54 EASTERN PROMENADE PORTLAND, MAINE
MORIN DRAFTING GORHAM, ME. 318-117
RENOVATION

FLOOR PLAN-SECOND FLOOR

FLOOR PLAN-SECOND FLOOR

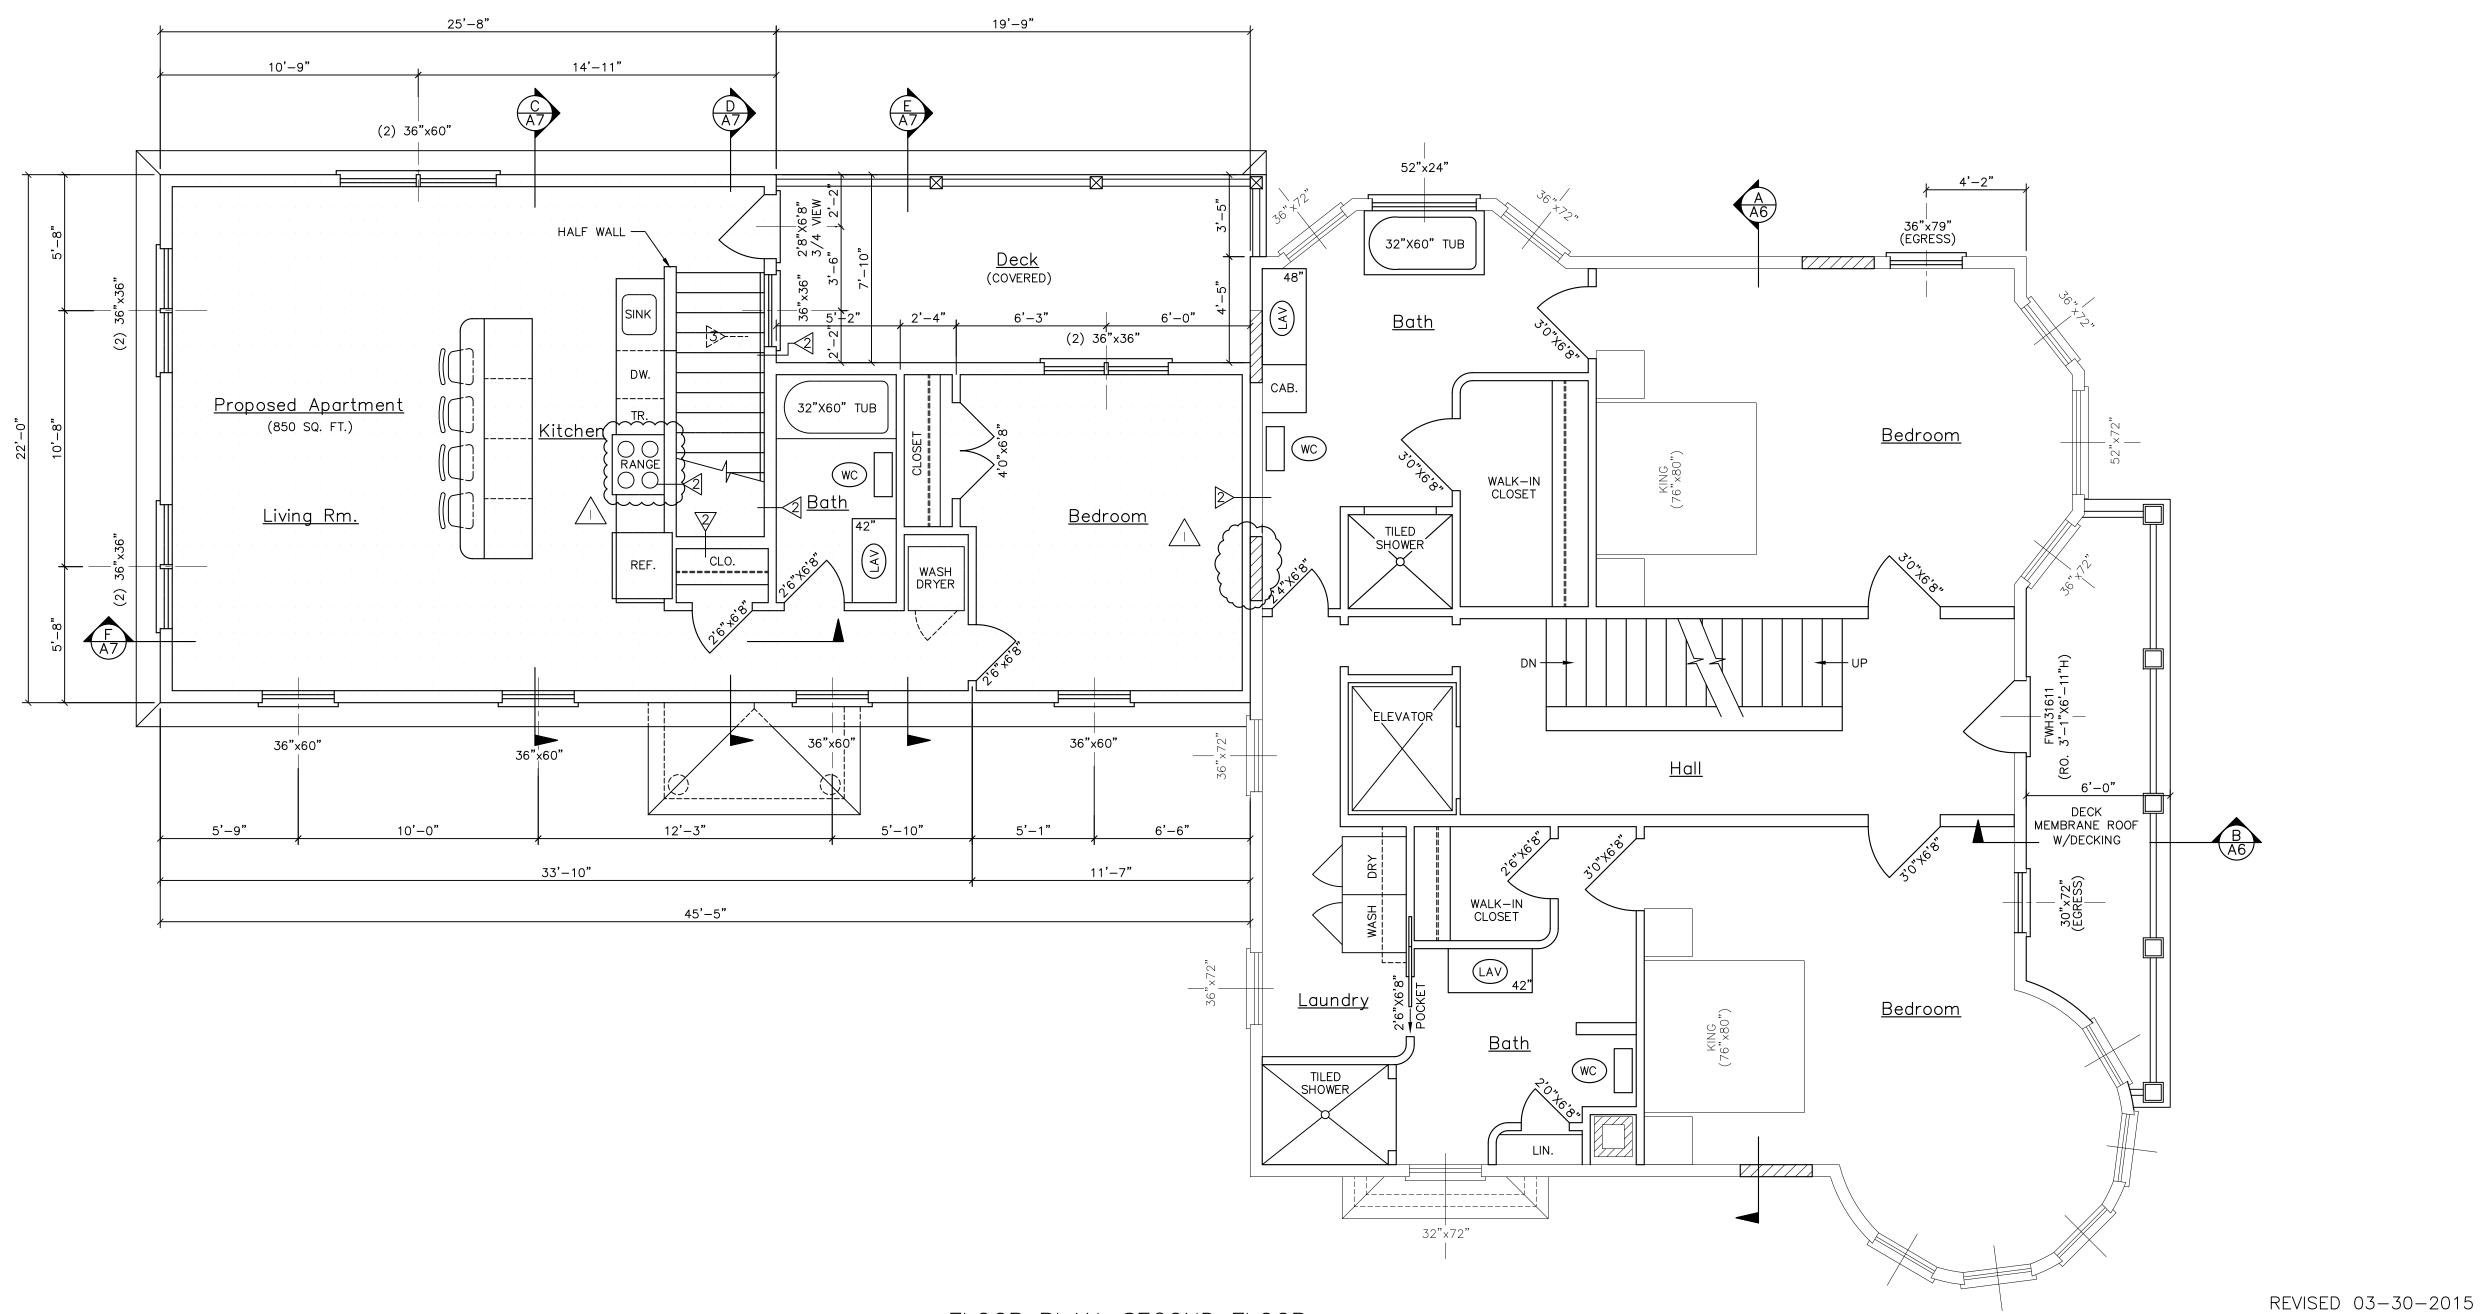
REV. 1 REMOVED ACCESS DOOR, INFILLED W/STUDS, INSULATION & GYPSUM BD. ADDED STOVE
